[Docket No. FAA-2007-28661; Directorate Identifier 2007-NM-013-AD; Amendment 39-16785; AD 2011-18-03]

Airworthiness Directives; The Boeing Company Model 737-600, -700, -700C, -800, and -900 Series Airplanes

ACTION: Final rule.

Figure 1

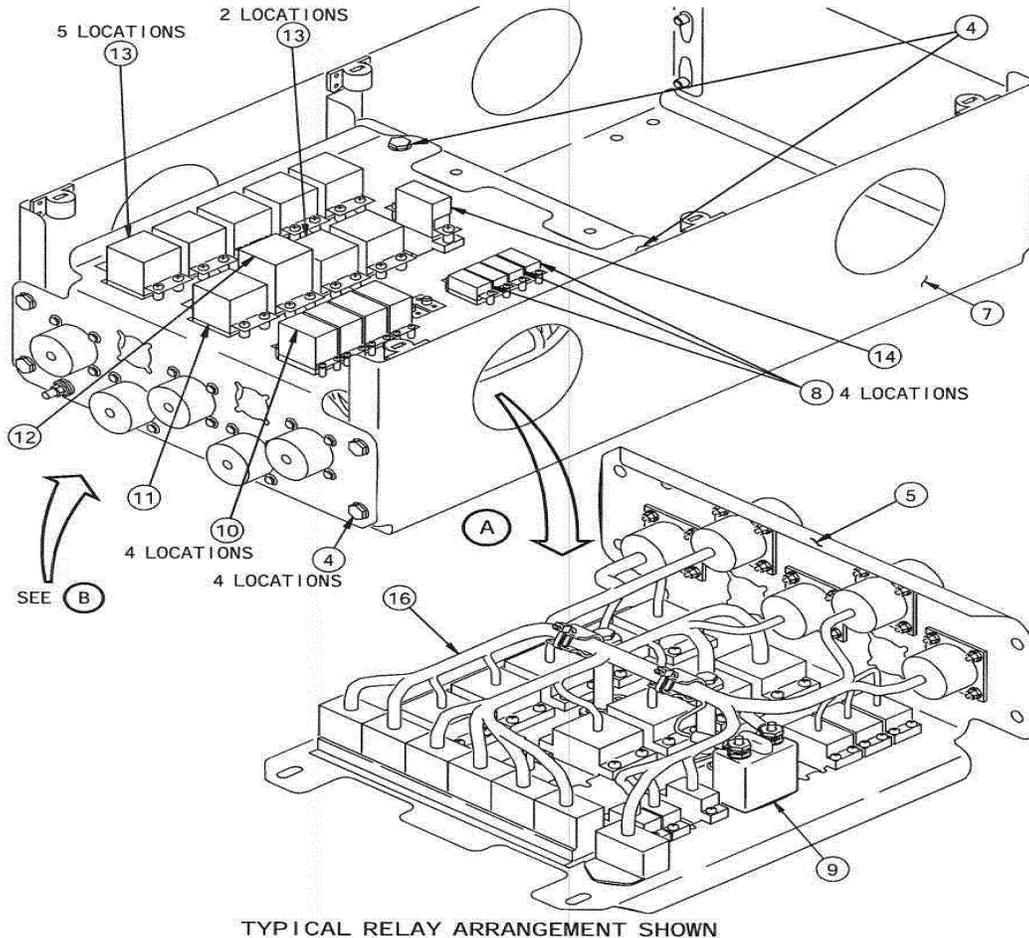
Part 1 and Part 2 of the Accomplishment Instructions of Boeing Alert Service Bulletin 737-28A1206, Revision 2, dated May 21, 2009, except that Figure 1 of this AD must be used in lieu of Sheet 2 of Figure 11 of Boeing Alert Service Bulletin 737-28A1206, Revision 2, dated May 21, 2009. If a placard has been previously installed on the airplane in accordance with paragraph (h) of this AD, the placard may be removed from the flight deck of only that airplane after the automatic shutoff system has been installed. Installing automatic shutoff systems on all airplanes in an operator's fleet, in accordance with this
